LiDAR Quality Assessment Report

KS_Area3-Southeast_2012

KS_25 COUNTIES LIDAR #1

Lot 1 of 6 lots.

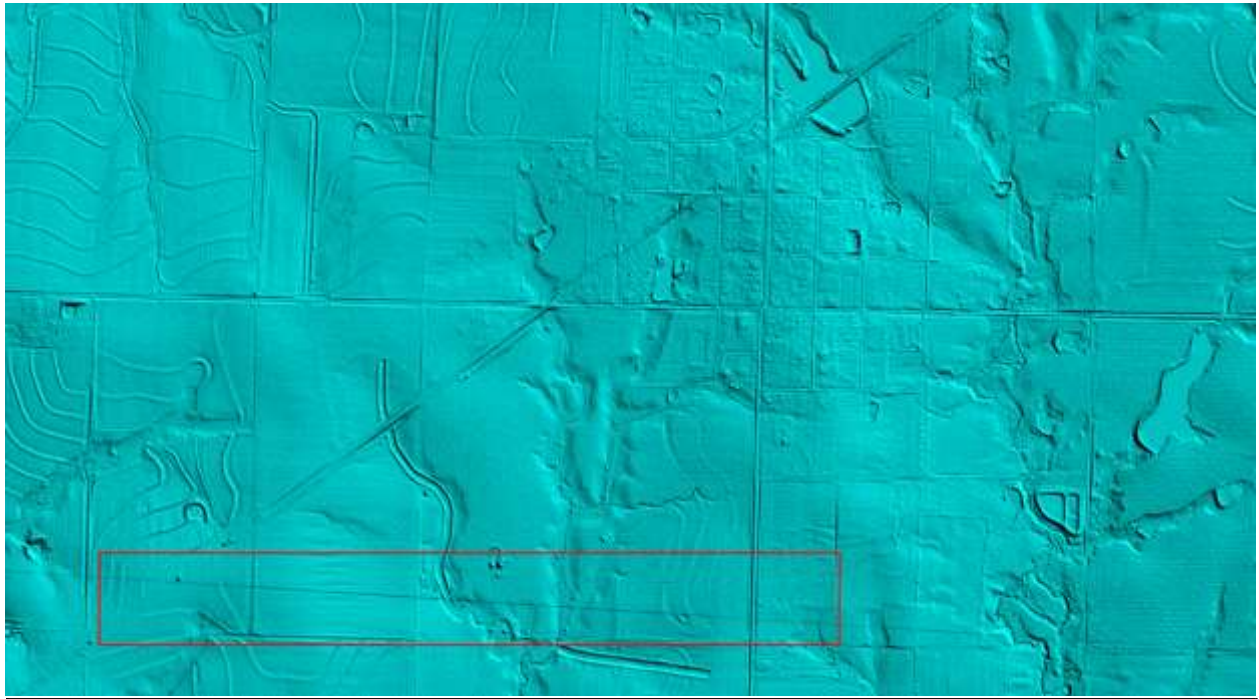
Visual anomaly in the DEM, however, not visible when hillshade turned off. Location at 37° 39' 12.9171" N, 94° 58' 36.7622" W. Does not affect the DEM.
